STAFF REPORT
DATE: 12/3/2024
REGULAR AGENDA

TO: City Council
FROM: Nathan Fuerst, AICP, Consulting Planner
AGENDA ITEM: **Discussion Only – Limerick Village Sketch Plan Review**
REVIEWED BY: Jason Stopa, Community Development Director

MEMORANDUM

RE: Limerick Village Sketch Plan Review

x:\2021\210010\concepts\revised site layout 3-2024\revised apartment layout\210010- density exhibit.dwg

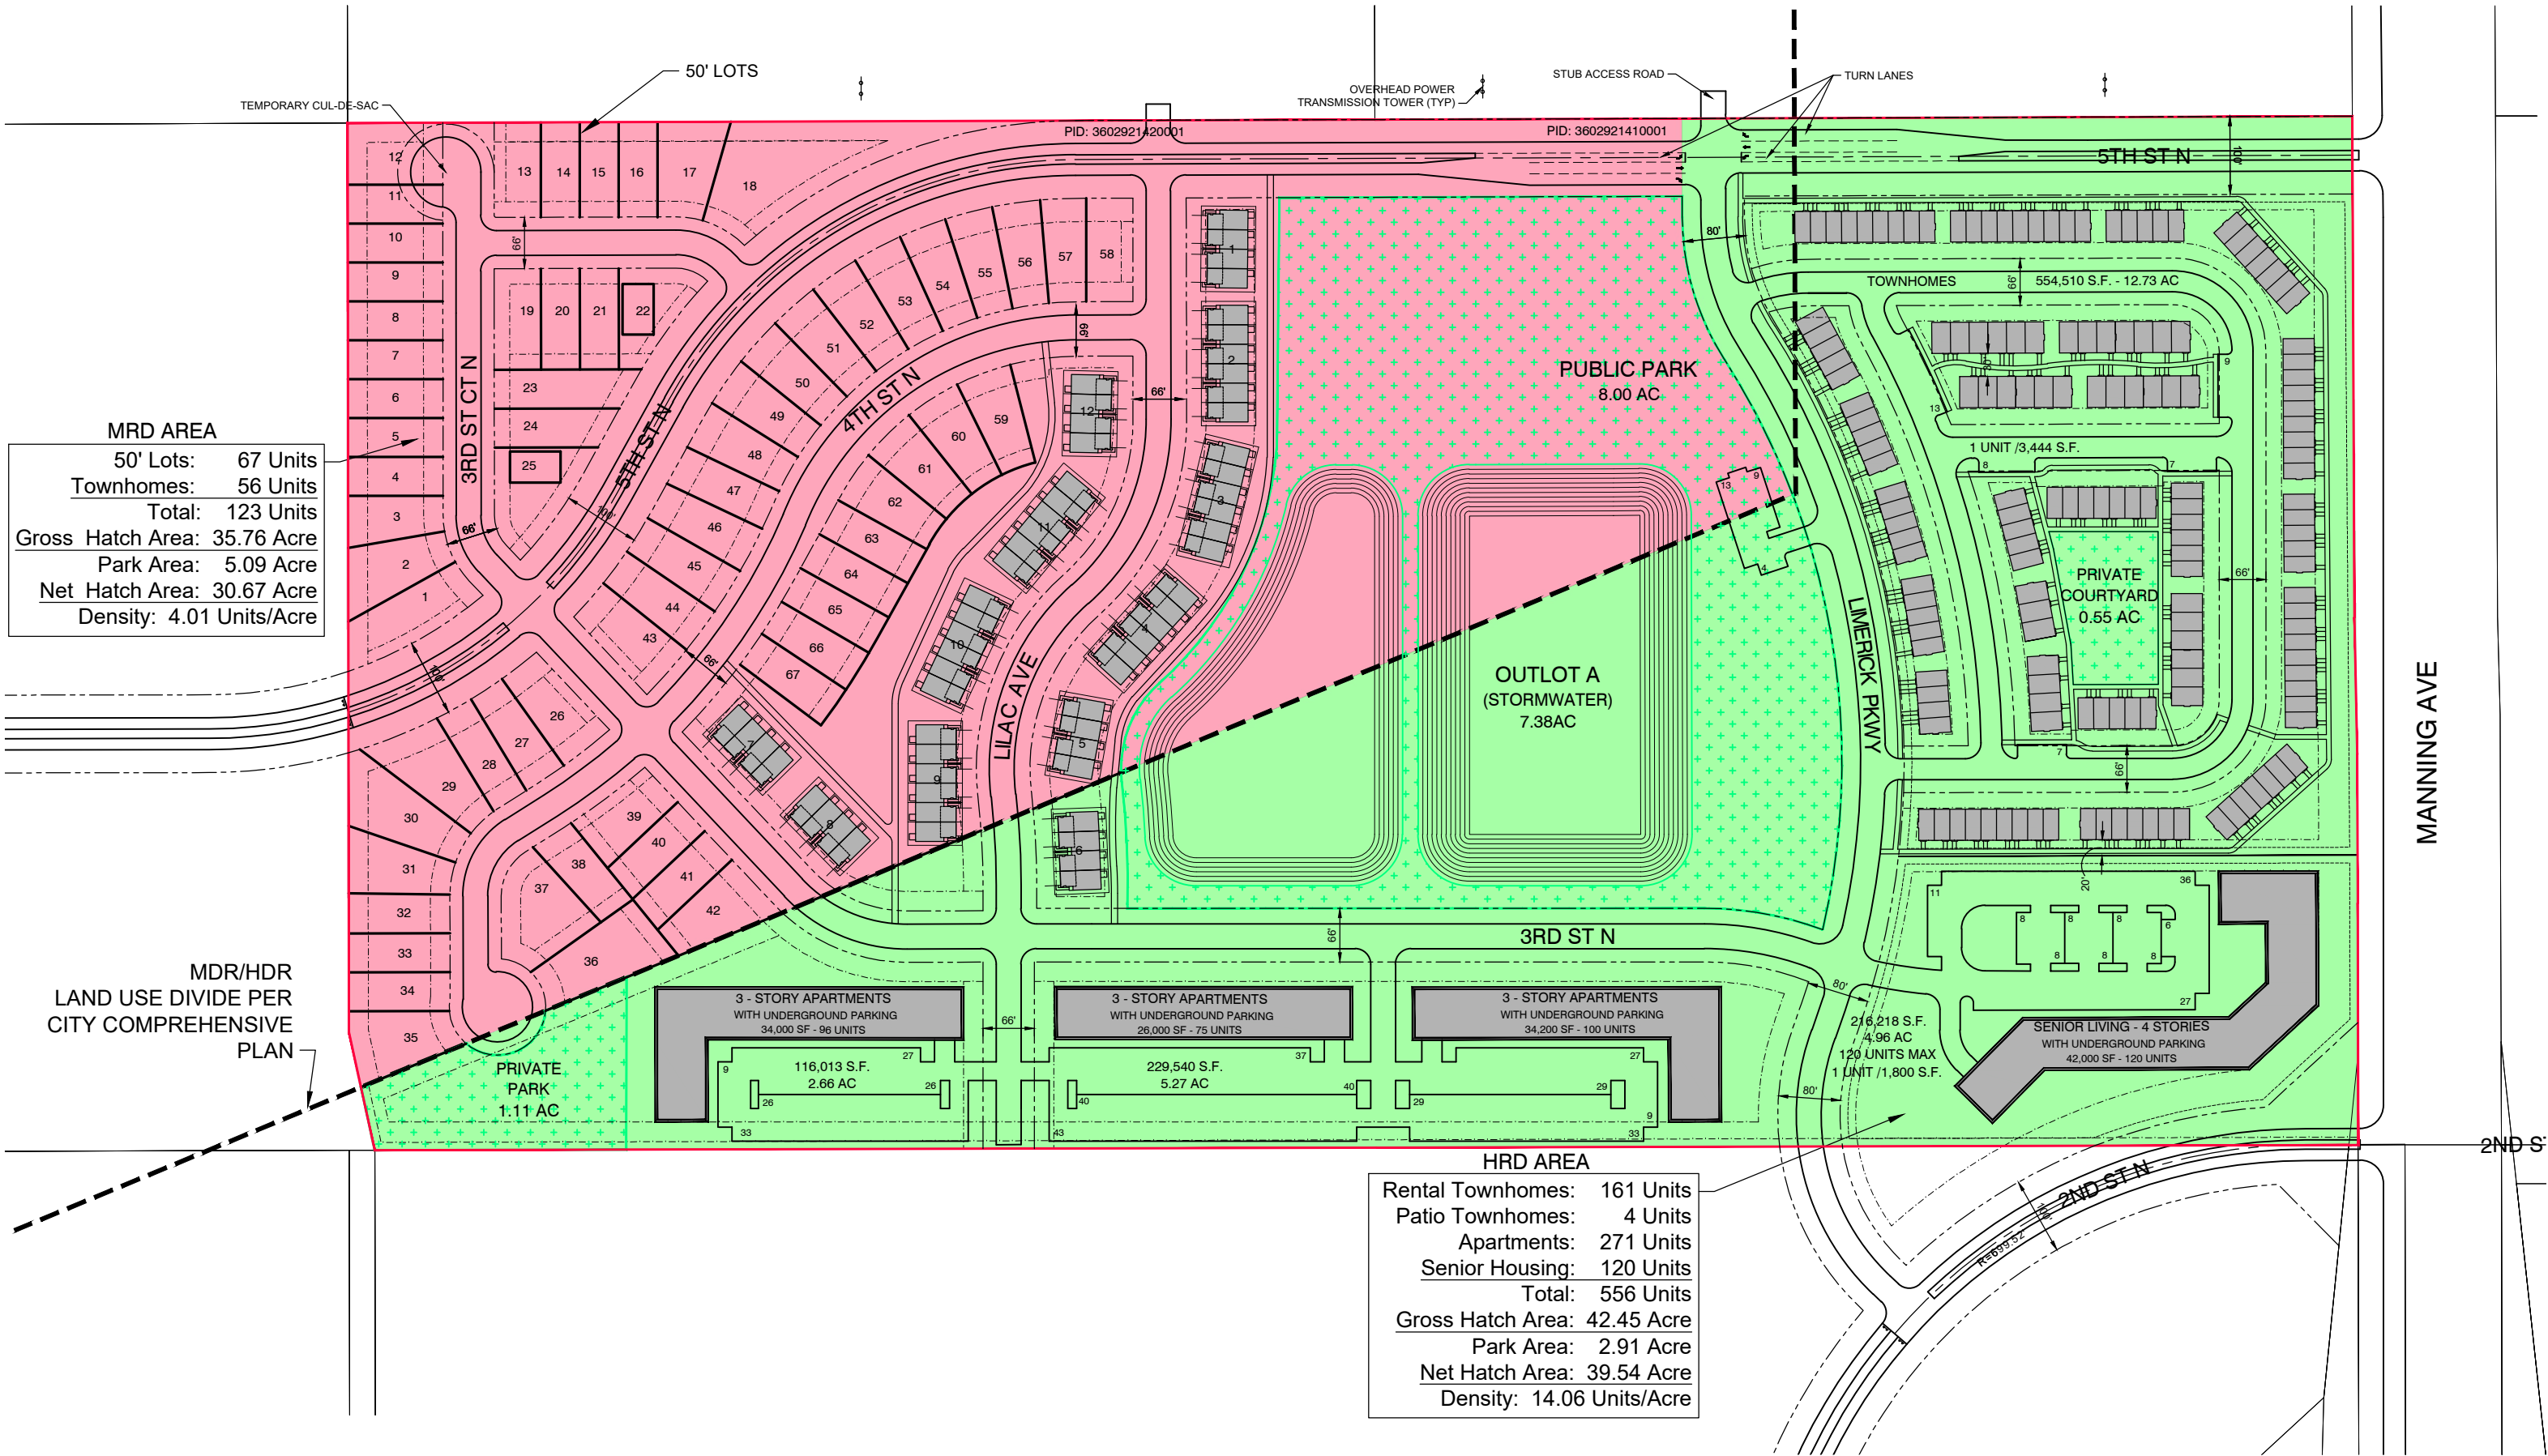
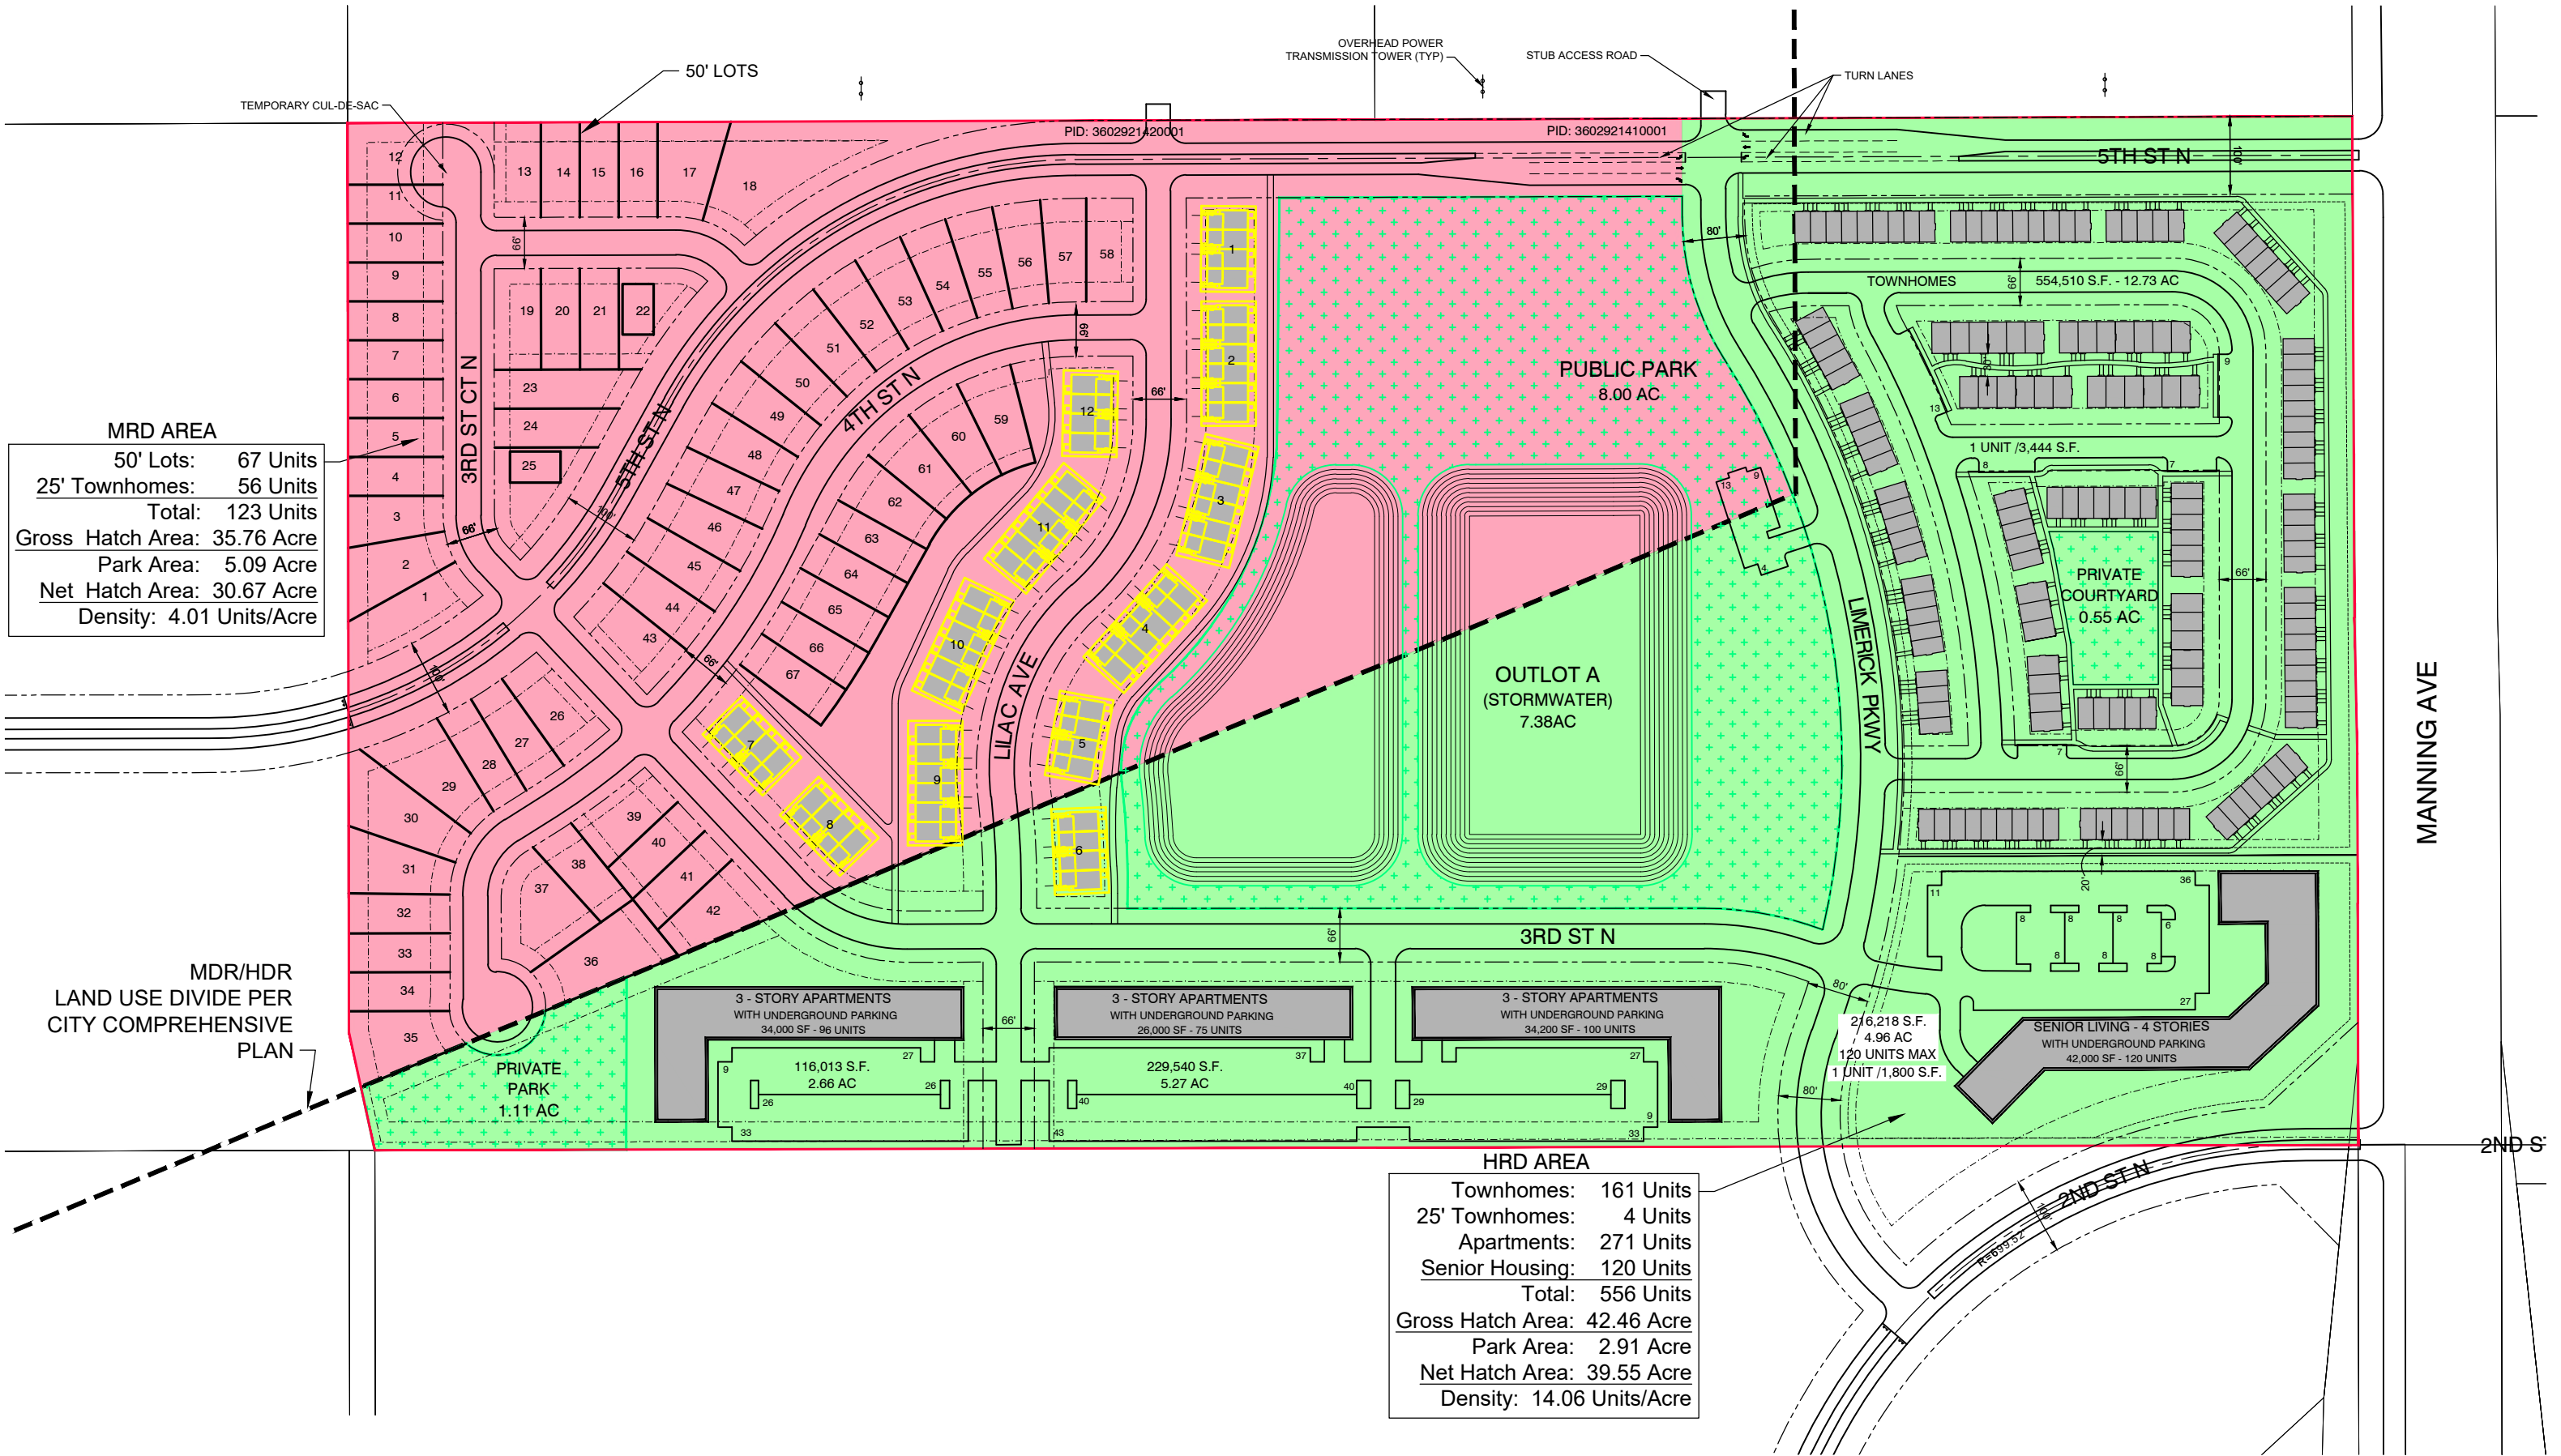
Net Acres Proposed	Units Proposed	Density Proposed	Min – Max Units
HDR (8.01 – 15 units/ac)	40.69*	556	13.66	326 – 611
MDR (4.01 – 8 units/ac)	31.5*	126	4.00	126 – 252
Total	72.19	682	9.45	452– 863

*City Staff were advised by Met Council that the land to be dedicated as parkland to the City must be netted out of the density figure. Net acreage will vary if parkland areas change.
